# Access Compliance Report

## Public Rights-of-Way

Intersection ID: 17601	Main Street: E_INDEPENDENCE_BV	Cross Street: CITY_VIEW_DR	Location: NE
ADA ID: ECFF34E1F841	Ramp Type: PerpDiag	Initial Pass/Fail: Fail	Overall Compliance: No
Severity Score: 37.5			
Codes/Mitigation Info/Possible Solution		Field Measurements/Component Compliance

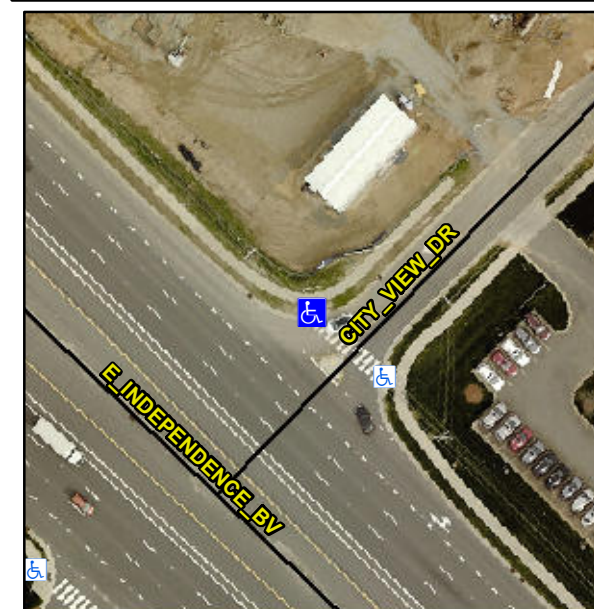
Compliance	Description	Data	Compliance	Description	Data
N/A	Ramp Length (in)	71.0	No	Ramp Slope (%)	10.9
Yes	Ramp Width (in)	58.0	No	Ramp XSlope (%)	9.0
N/A	Flare Type LT	N/A	N/A	Flare Type RT	N/A
N/A	Flare Slope LT (%)	N/A	N/A	Flare Slope RT (%)	N/A
N/A	Flare Traversable LT?	N/A	N/A	Flare Traversable RT?	N/A
N/A	Landing Length (in)	N/A	N/A	DWS Provided?	N/A
N/A	Landing Width (in)	N/A	N/A	DWS Contrast?	N/A
N/A	Landing Slope (%)	N/A	N/A	DWS Length (in)	N/A
N/A	Landing X Slope (%)	N/A	N/A	DWS Full Width?	N/A
N/A	Landing Curb? (Y/N)	N/A	N/A	DWS Offset (in)	N/A
N/A	Shared Landing?	N/A			
N/A	Gutter Ponding?	N/A	N/A	Gutter Slope (%)	N/A
N/A	Gutter Lip Ht (in)	N/A	N/A	Gutter X Slope (%)	N/A
N/A	Painted X Walk1?	No	N/A	Painted X Walk2?	Yes
	X Walk 1 Direction	To SW		X Walk 2 Direction	To SE
N/A	X Walk 1 Width (in)	N/A	N/A	X Walk 2 Width (in)	118.0
	X Walk 1 Slope (%)	9.0		X Walk 2 Slope (%)	2.6
	X Walk 1 X Slope (%)	0.4		X Walk 2 X Slope (%)	7.3

N/A	Ramp inside XWalk1?	N/A	N/A	Ramp inside XWalk2?	Yes
	Road Slope (%)	6.0	N/A	Clear Space?	N/A
	Road X Slope (%)	6.1	N/A	Clear Space to XWalk (in)	N/A
N/A	Any Obstructions?	N/A	N/A	Storm Grate/Utility Hazard?	N/A
	Obstruction Type			Storm Grate/Utility Type	
		N/A			N/A
		Yes		Surface Condition? (G/P)	Good

**Remove & Replace Curb Ramp With Two New Directional Ramps or Equivalent.**

**R304.2.2, R304.5.3**
